December 6, 2024

IDEA PUBLIC SCHOOLS – Upper Valley Building Envelope

ADDENDUM NO. 5

A2.05

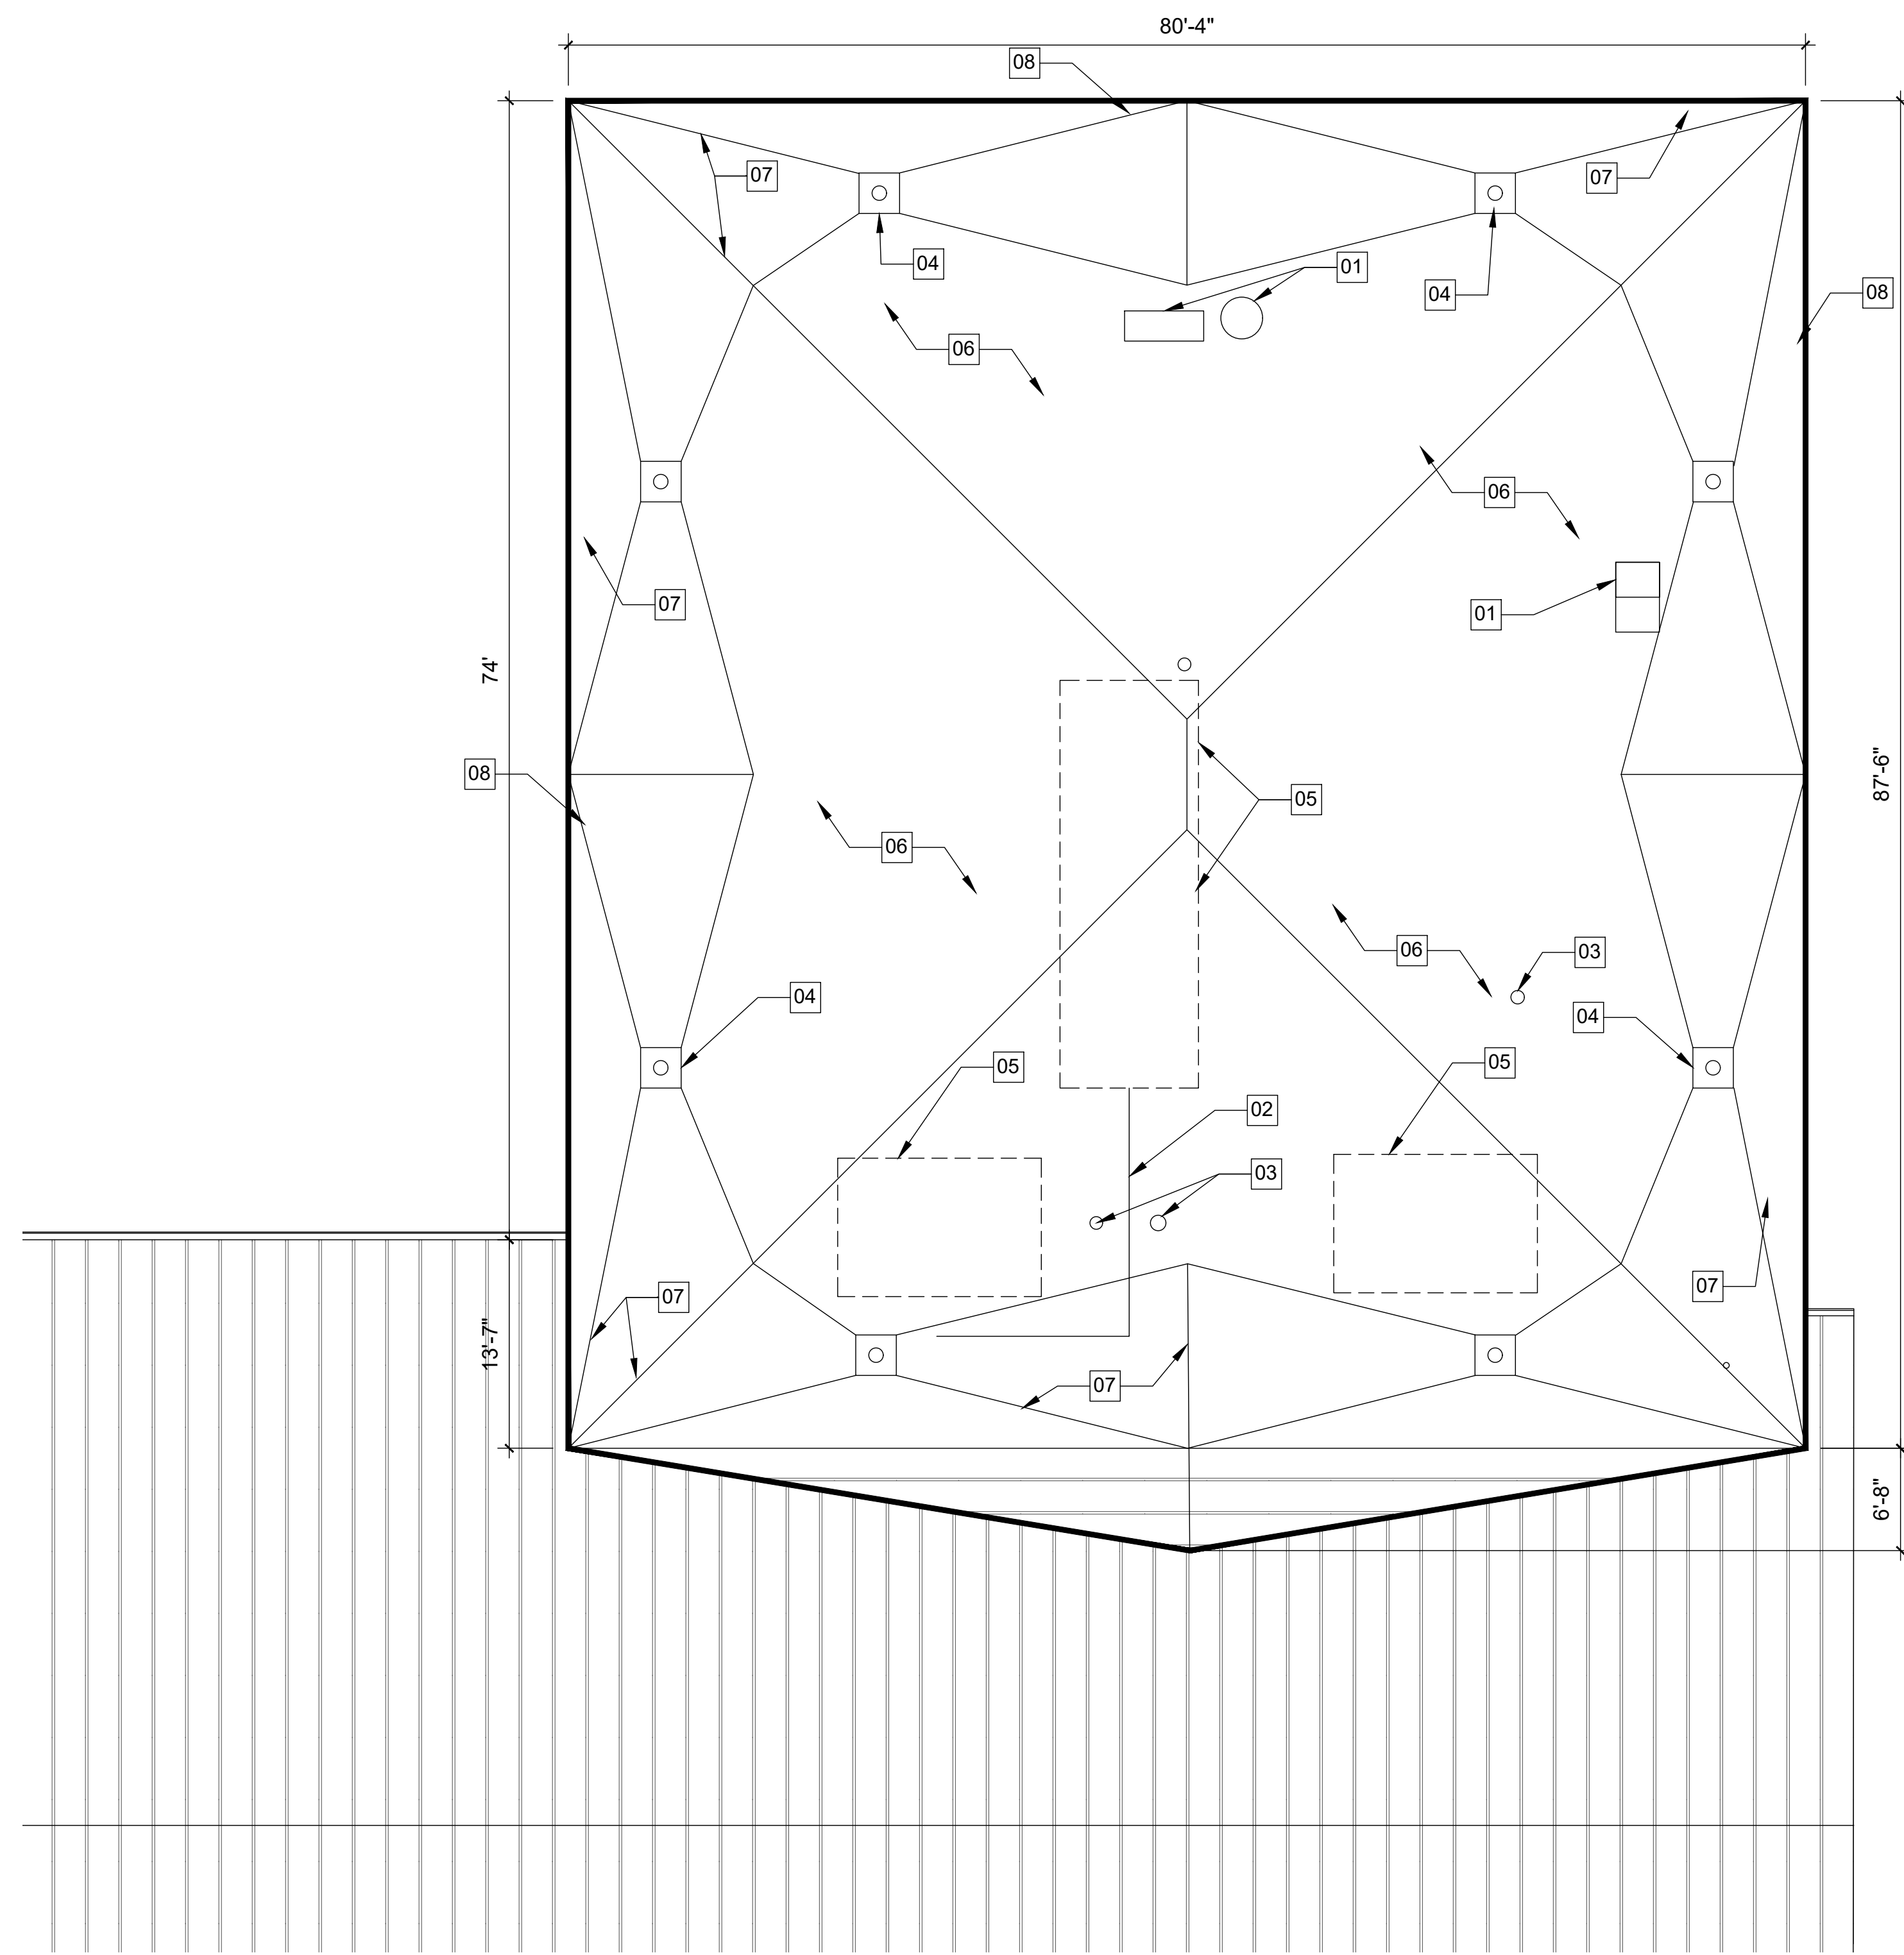
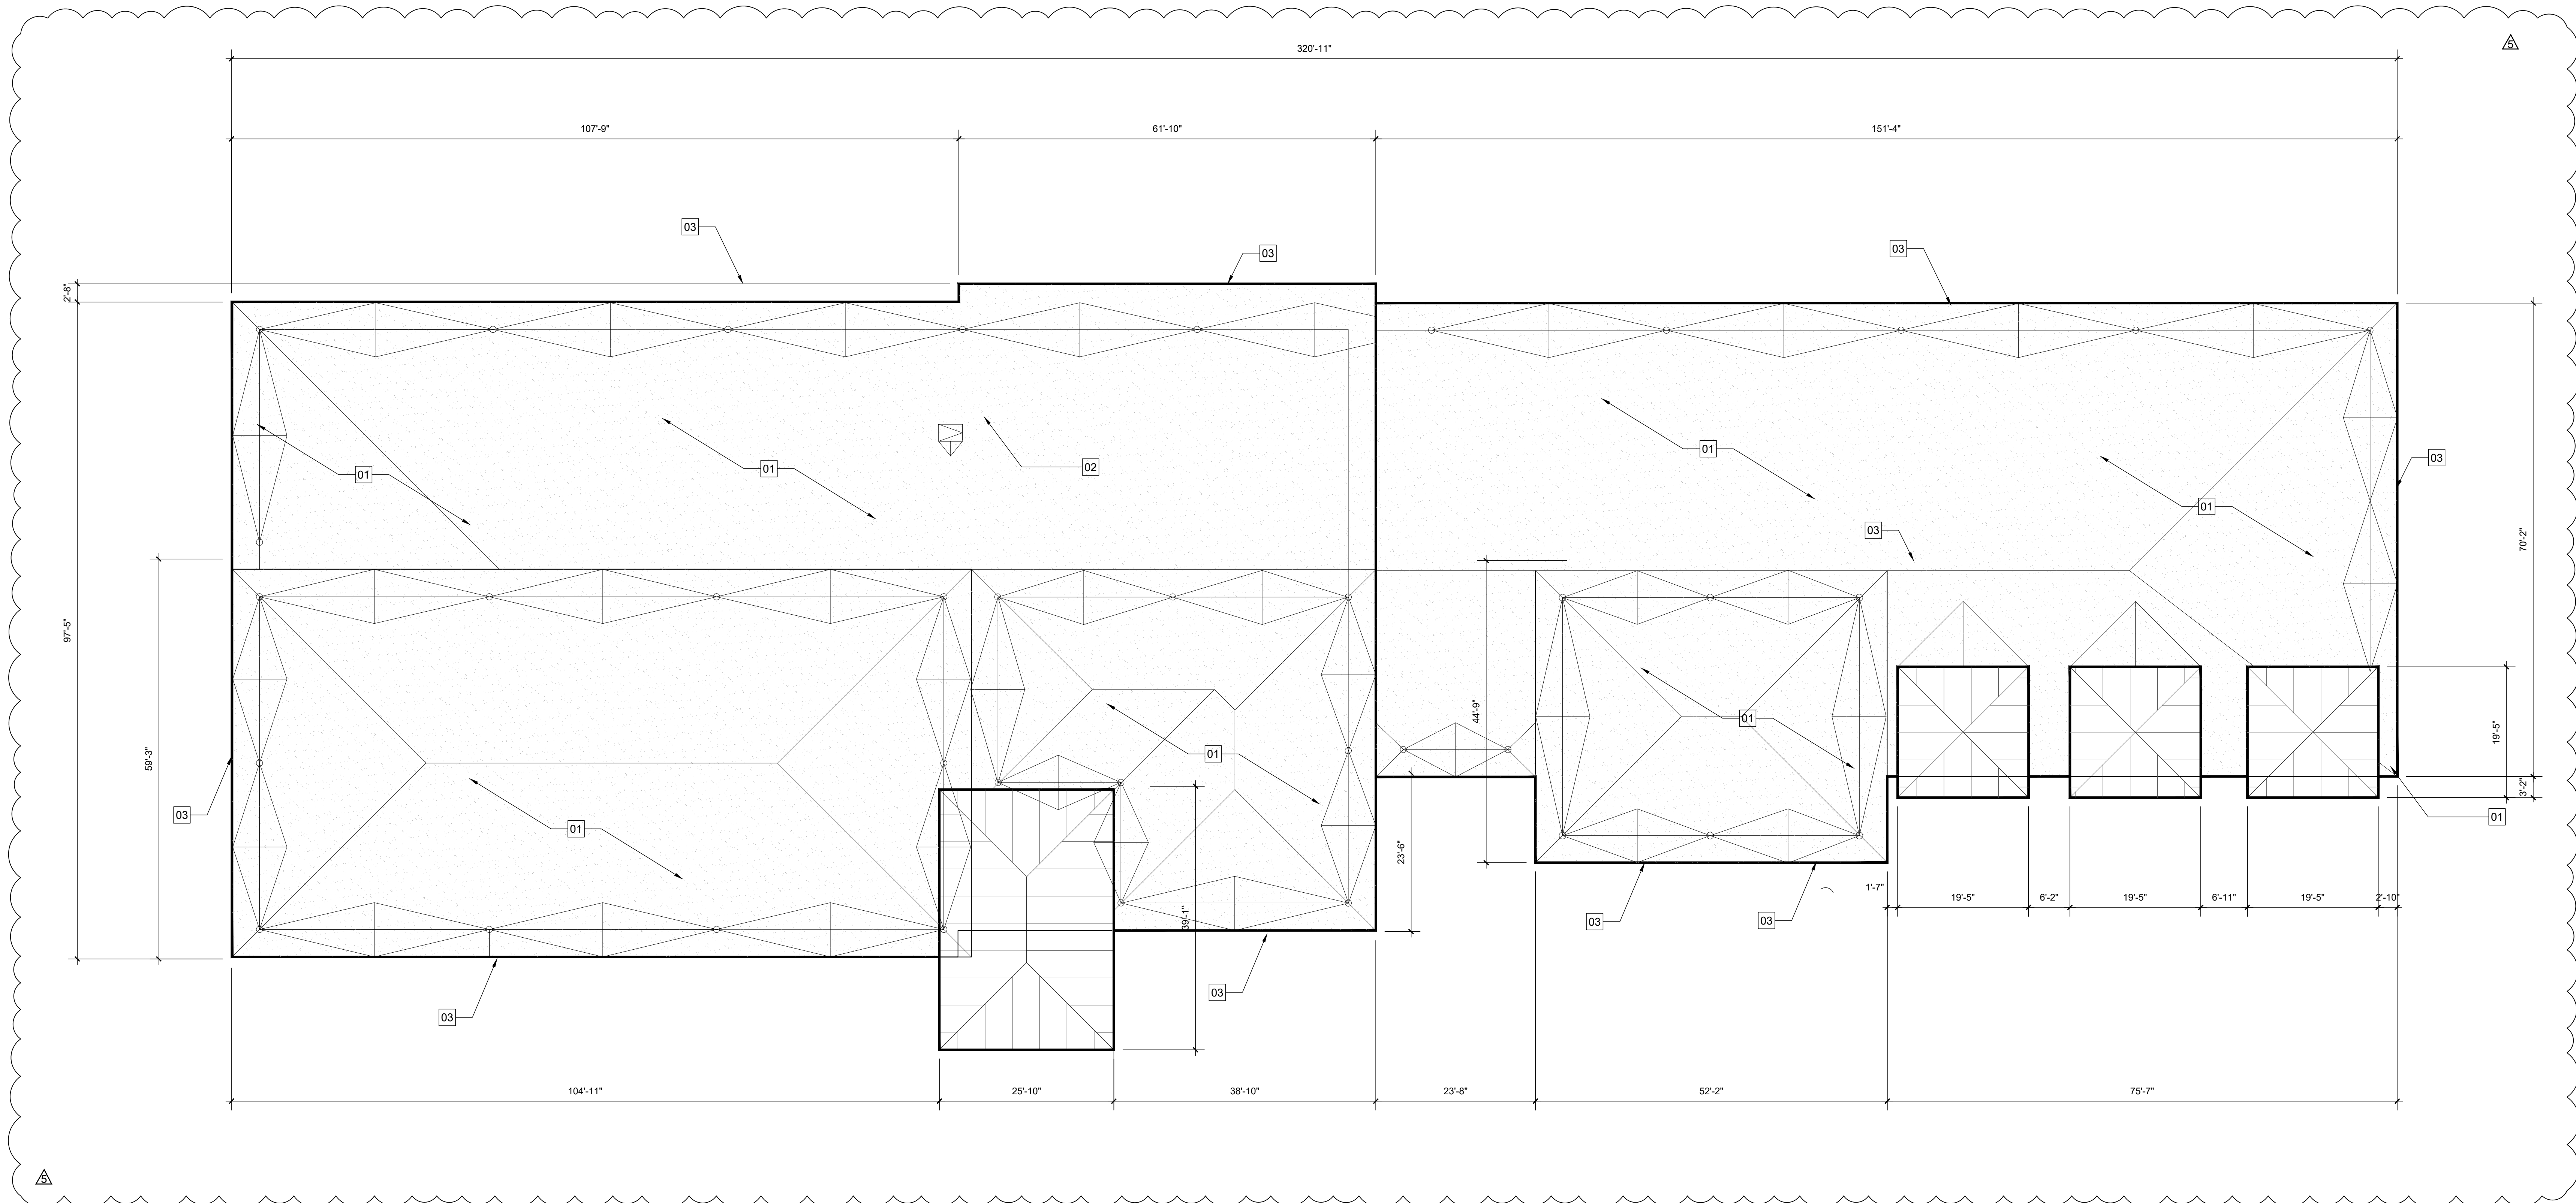
- Leaking covered walkways pertain to degraded gutter/downspouts. Replace gutter/downspout at covered walkway.
- Add through wall scupper to wall/roof opposite of roof drains at Building E (modified roof).
- Campus buildings have bullet holes in them. Provide unit price for replacing roof panels.
- Dimensions have been corrected on modified roof building.

- Delete IDEA Mission Sheet A2.05 from construction documents and replace it with attached IDEA Mission Sheet 2.05.
- Delete IDEA Edinburg Sheet A3.01 from construction documents and replace it with attached IDEA Edinburg Sheet A3.01.

ACADEMY
01 ROOF PLAN
 SCALE: 1/8" = 1'-0"

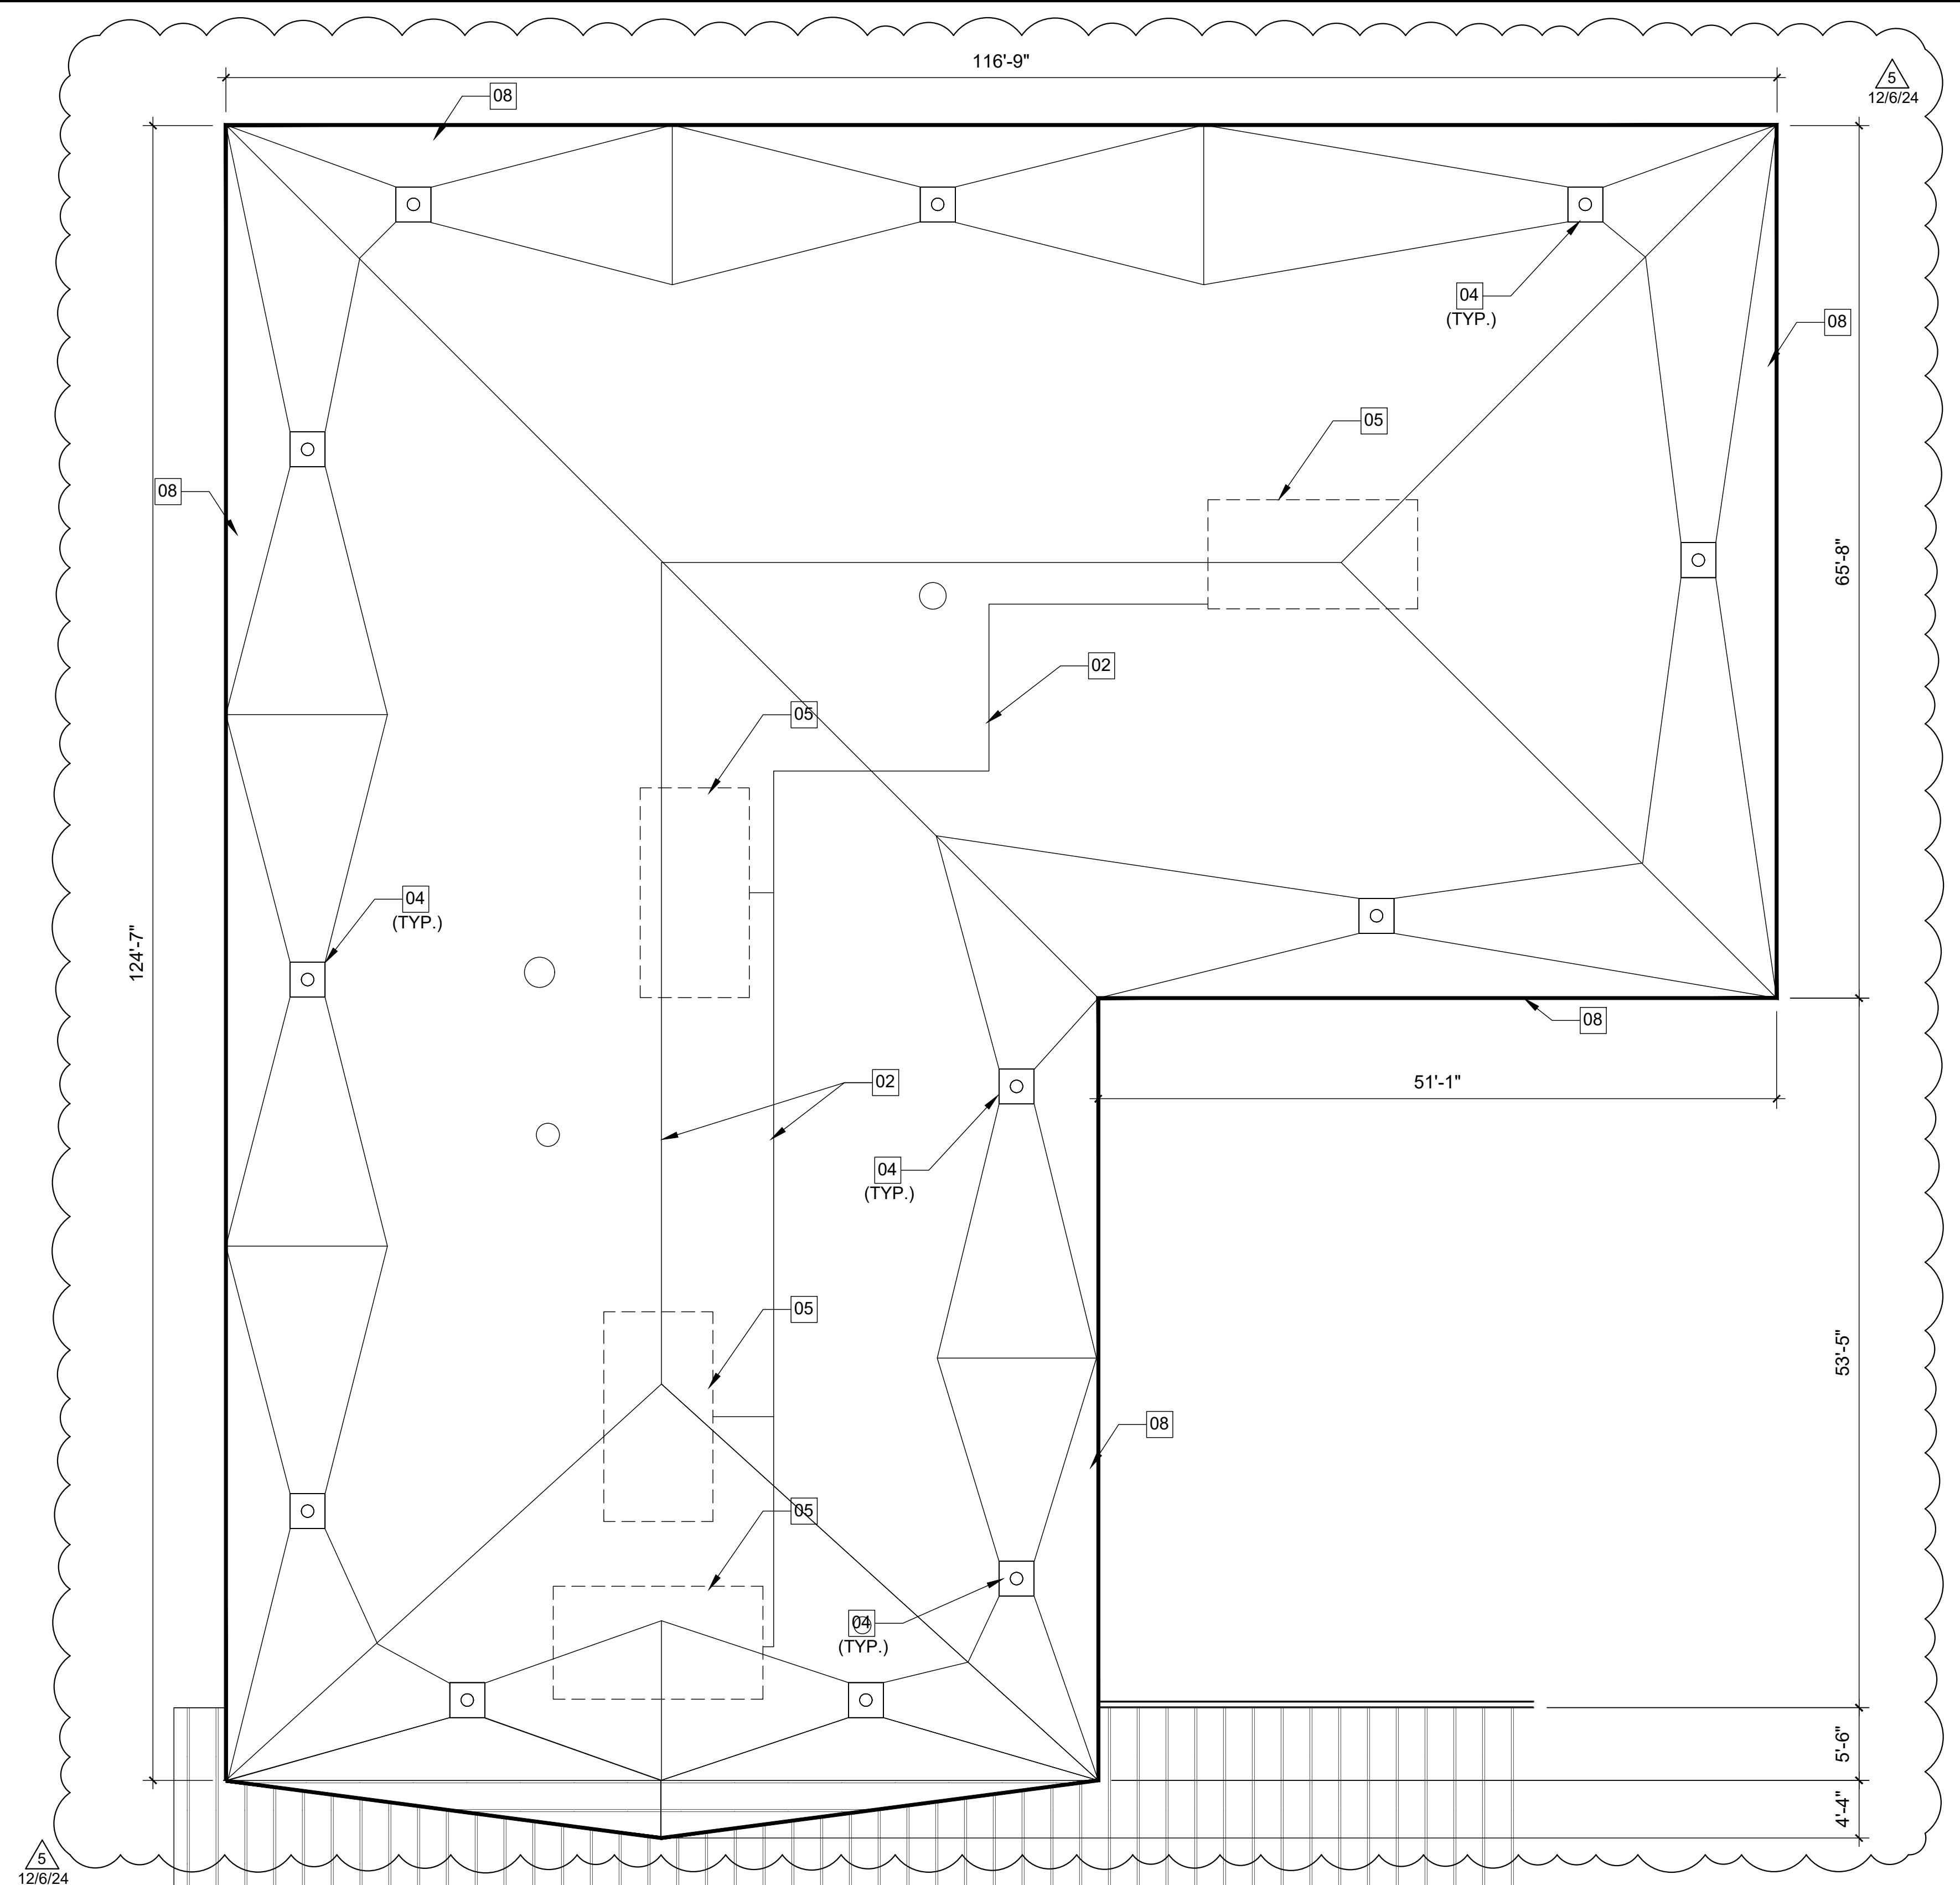
- Question: "...on the new bitumen roof on the IDEA Edinburg school where there are several RTUs, do we figure removing all the pitch pans and re-routing electrical & plumbing through new weather heads as specified in detail 02/A3.02?"
Answer: Yes, add or replace pitch pans and weather heads and re-route electrical and plumbing, typical.
- Replace gutters and downspouts for both Academy and College Prep buildings.
- Roof dimensions edited. Updated plans to be provided.
- Detail for transition from flat roof to metal roof to be provided.
